Proposal for Supplement 2 to the 03 series of amendments to UN Regulation No. 129

Submitted by the expert from Spain

1. Arrangements of the approval mark

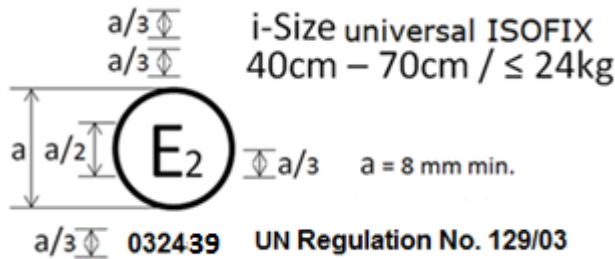
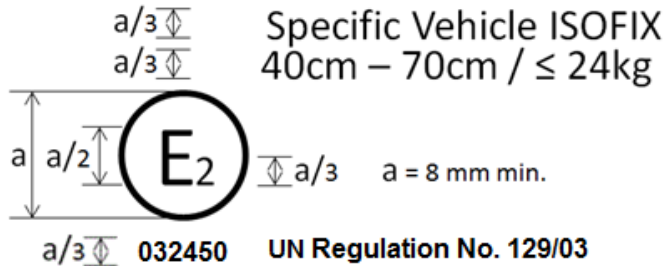
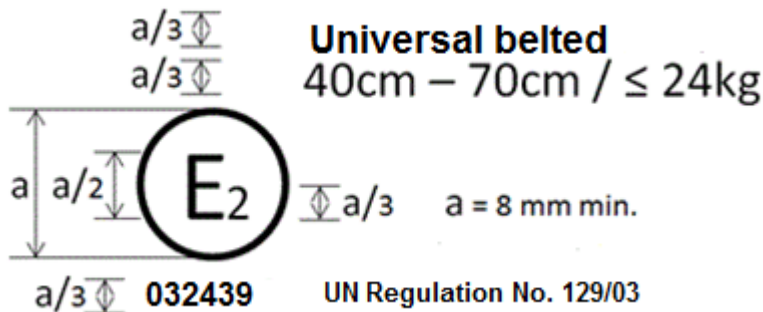
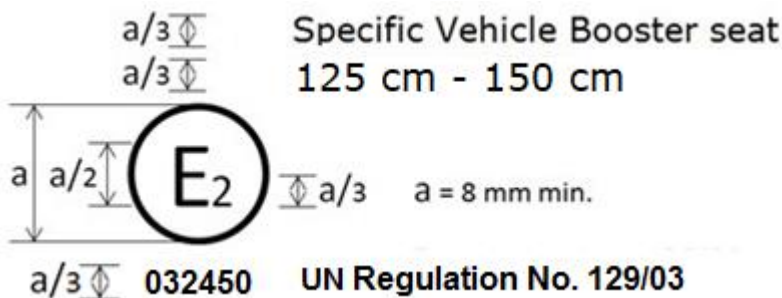
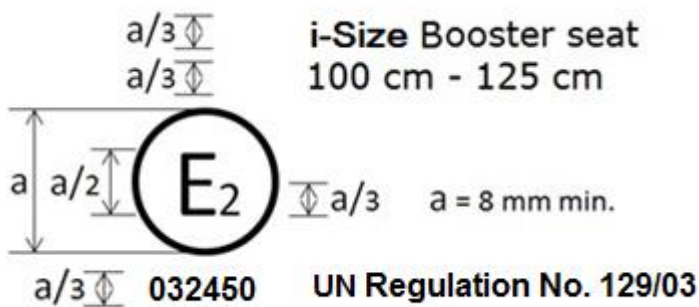
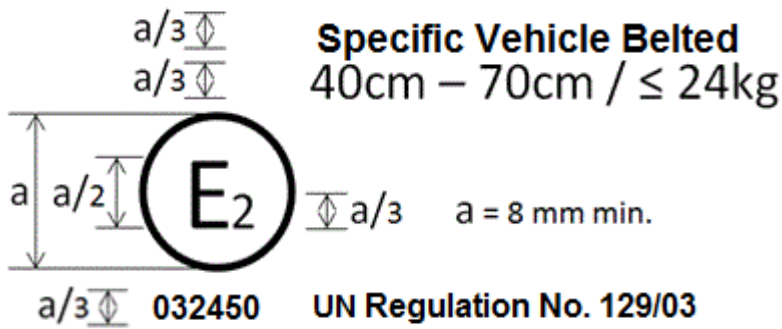
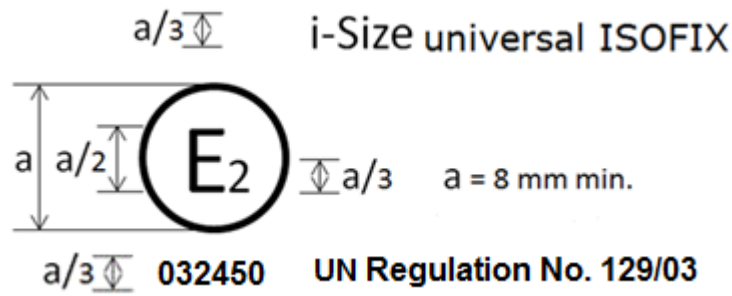
Annex 2., amend to read:

1. Dimension of the approval number is currently not specified
2. i-Size universal ISOFIX, Specific Vehicle ISOFIX, i-Size Booster seat and Specific Vehicle Booster seat are not updated to 03 numbering in ECE-TRANS-WP29-2018-045e
3. Dimensions marks for arrangements of the approval mark in combination with the module mark re-arranged.
4. Changed the 145 cm stature of the Specific Vehicle Booster seat to 150 cm stature as this is the upper limit.
